Plan Commission

Agenda

Monday, April 27, 2020

- ITEM 4: Staff recommendation and possible action regarding a proposed 32 lot final plat of Honeysuckle Acres Fourth Addition at 1500 BLK Red Maple Rd (Parcels WD-L183-4 & WD-L183-4-1).*

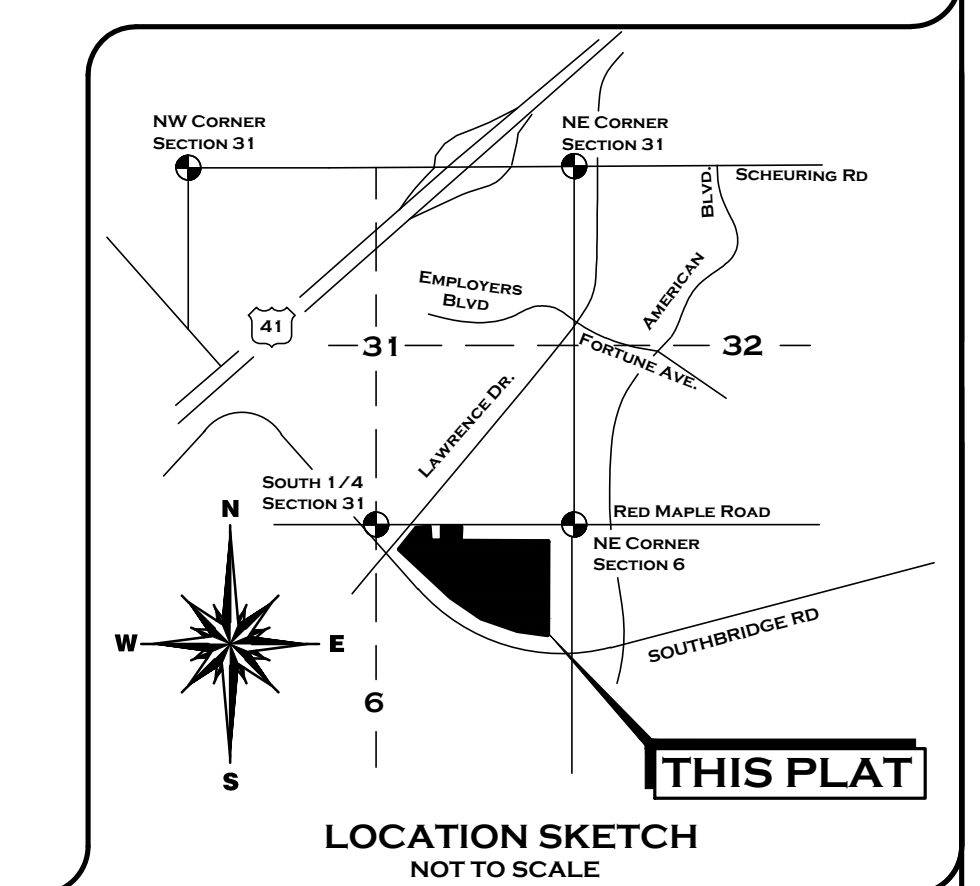
4. Update Covenant 7 to include: "All exposed walls with windows shall be approved by the City prior to constructing."
5. Update Covenant 10 to change the designated lots to 91 to 93.

6. Update the utility easement locations for the revised plat to include a 20-foot easement, centered along the lot line between Lots 66/67, 60/71, 75/76 (as shown), 82/83.

8. Add the following note: "There is a daylighted City storm sewer on Lot 77 and on Lot 90. These pipes shall become the responsibility of the property owner up to the Southbridge right of way or future inlet upon the reconstruction of Southbridge Road."

9. Clarify that Lot 77 properly has at least 85' of street frontage. Curve #15 indicates that part of the lot frontage is 172' long, which does not appear to be correct.

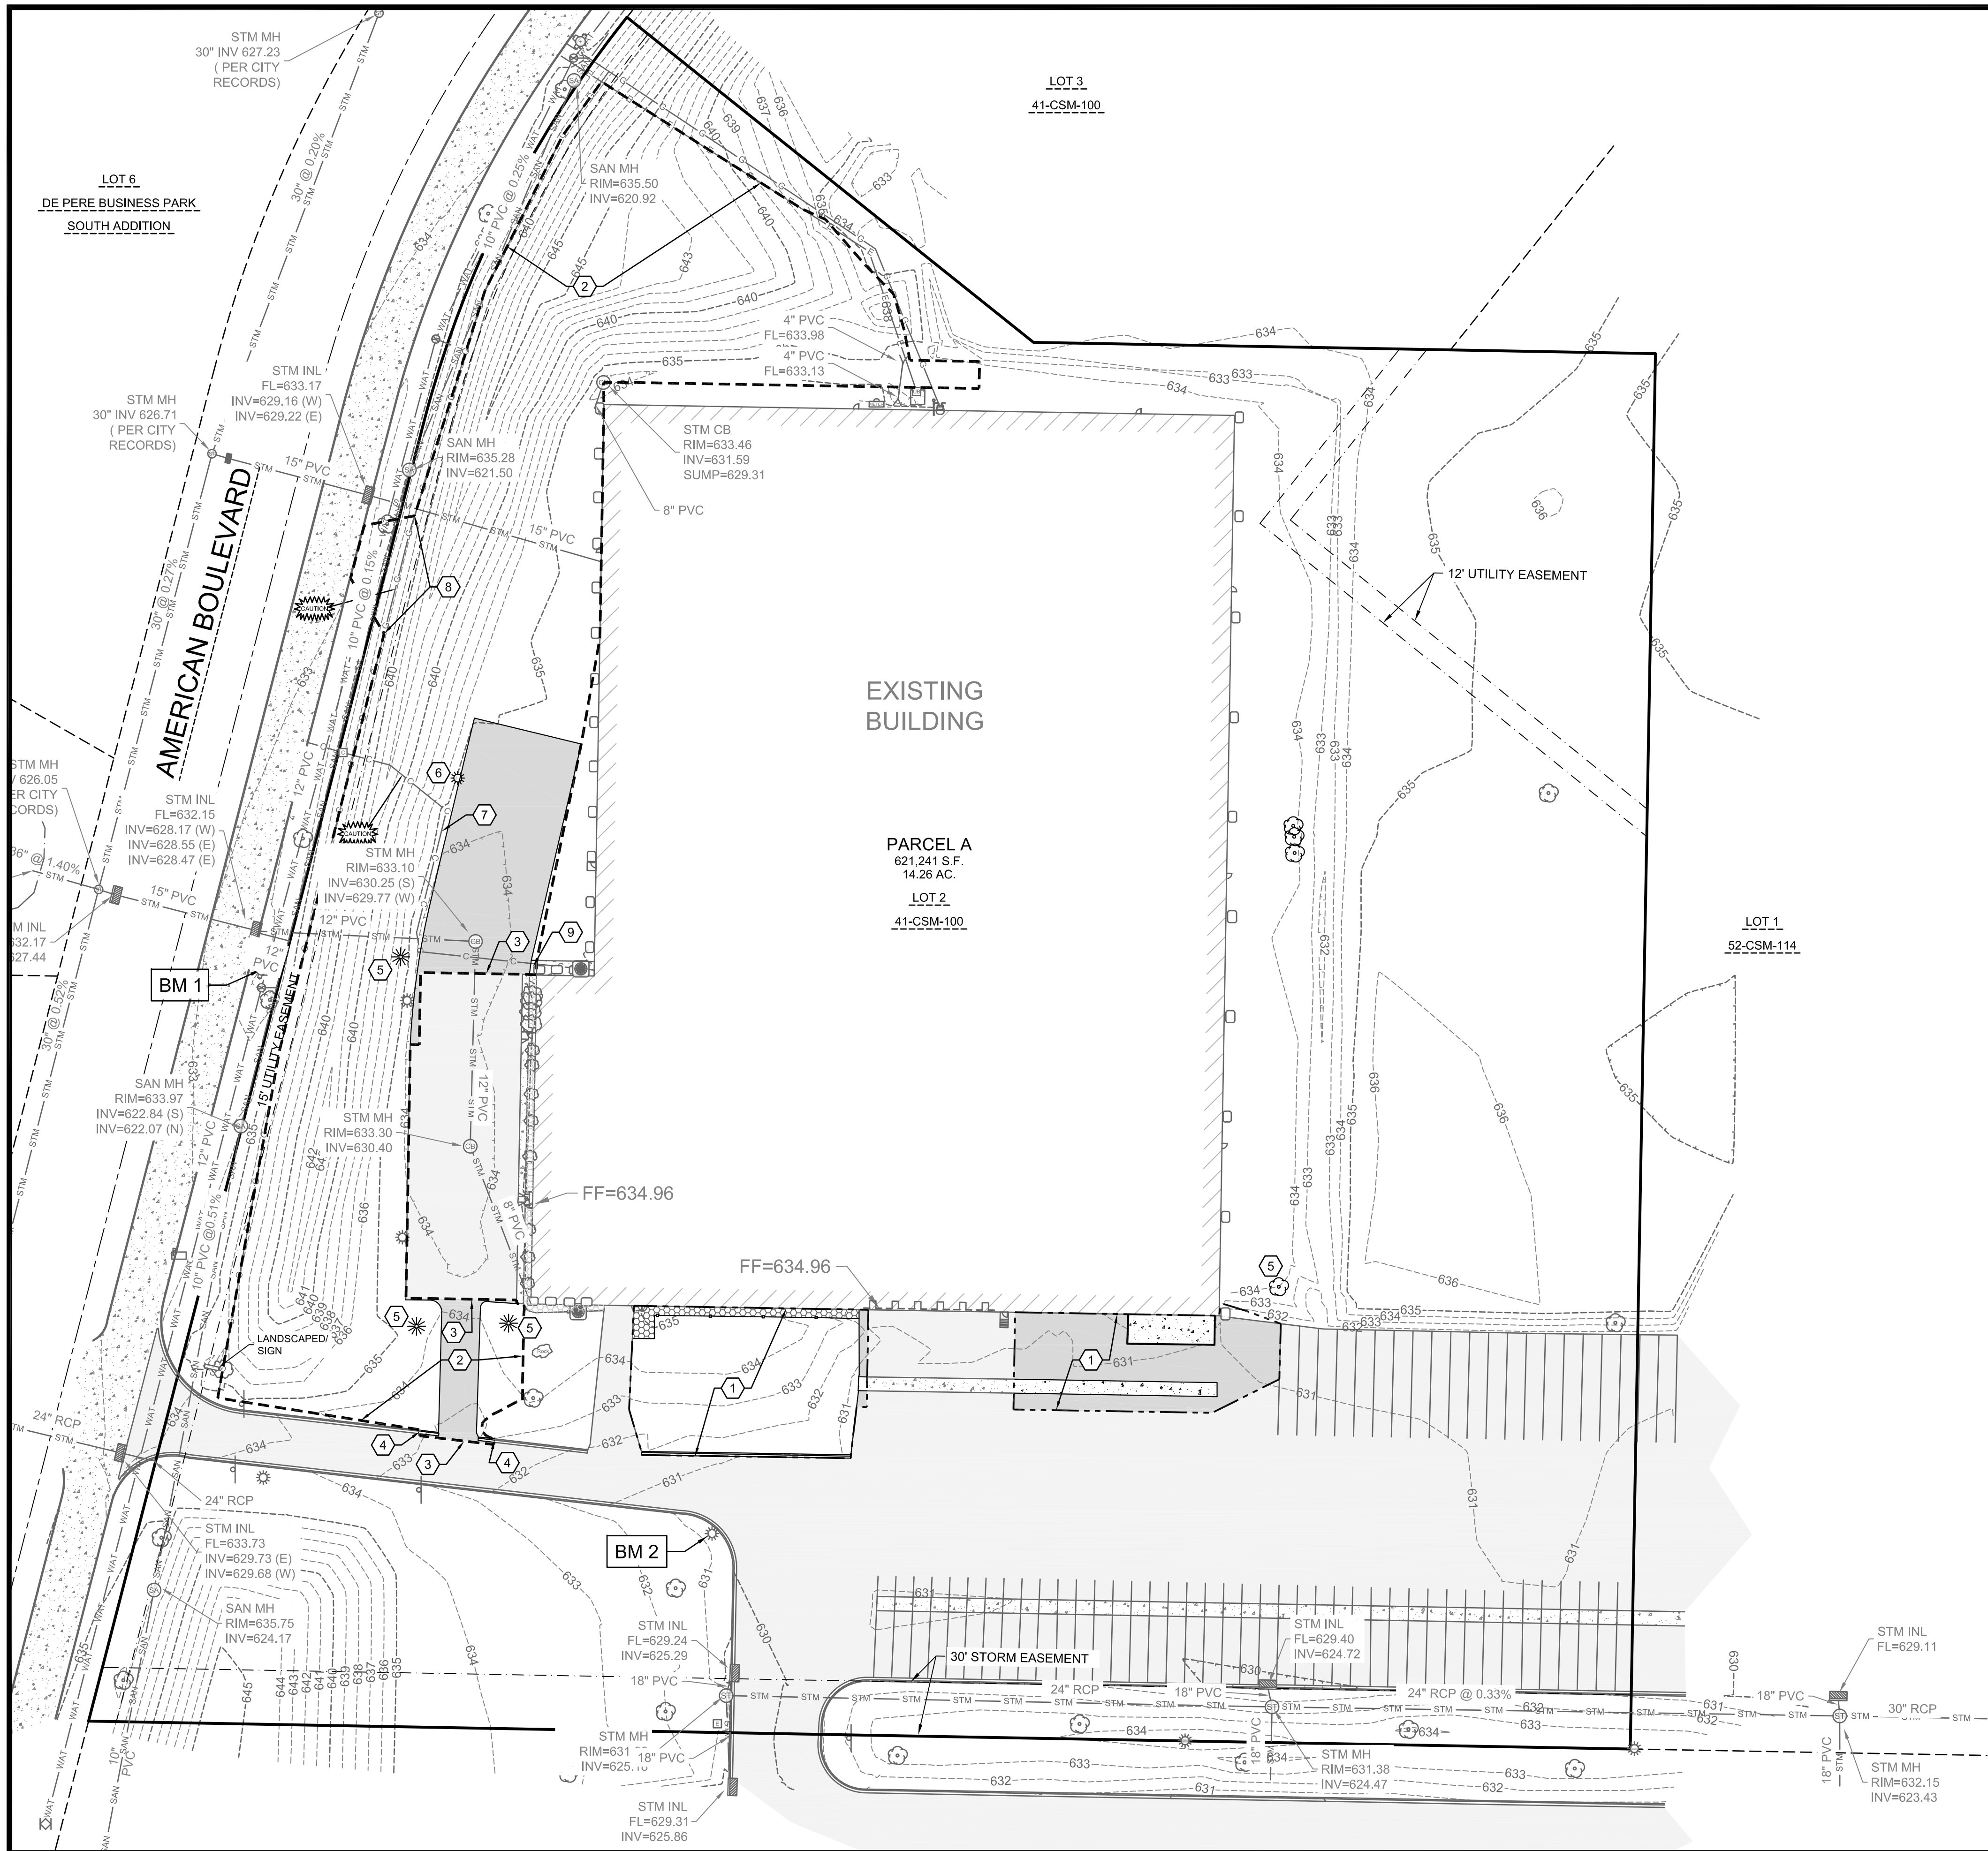
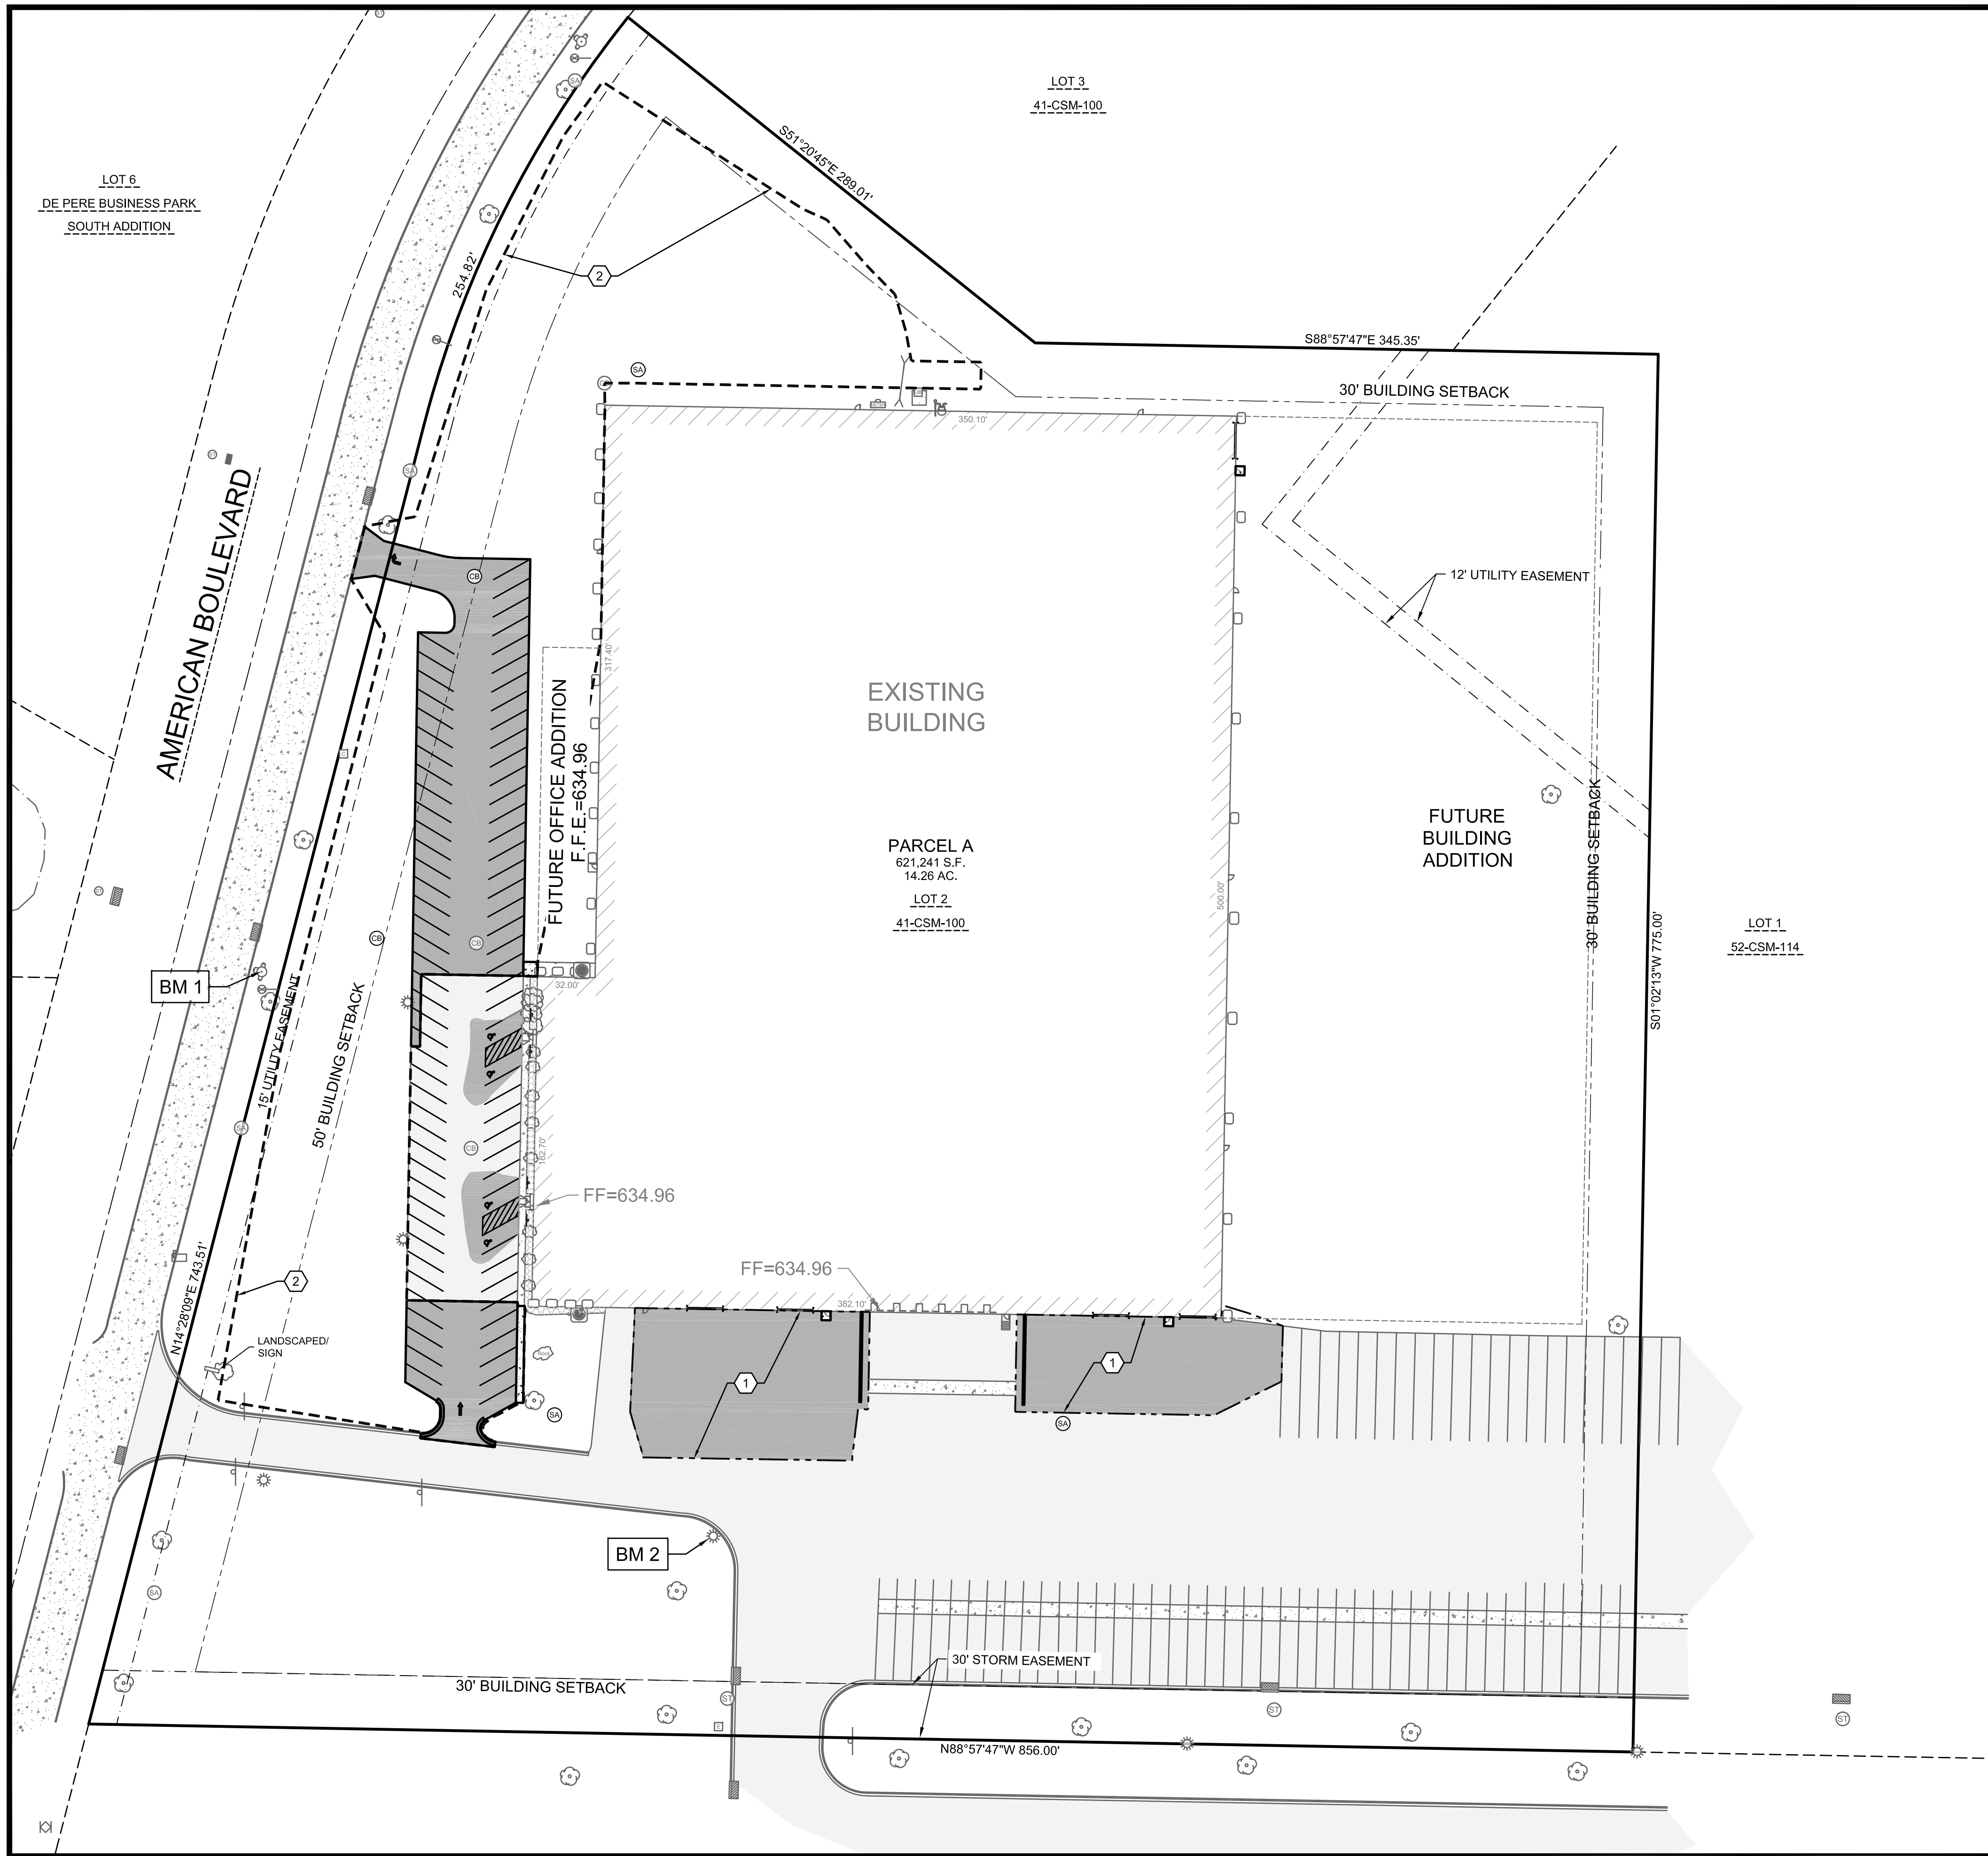
1. On Sheet C0.1:
 - a. Provide owner information.
 - b. Provide details for refuse collection if outdoor. If indoor, indicate on plans.
2. On Sheet C2.0:

- c. Driveway onto American boulevard shall be 8-inch concrete with a five-foot-wide sidewalk section set a half foot off of the right-of-way line.
3. On Sheet C2.1:

- c. Identify if a new 50-foot retaining wall is being constructed in the phase I limits.
 - d. Identify where is the light pole is being relocated.
4. On Sheet C3.0:

- h. Additional asphalt removals would be required for sanitary sewer.
5. On Sheet C5.0:
 - a. Provide soil loss sediment discharge calculations and a corresponding map.
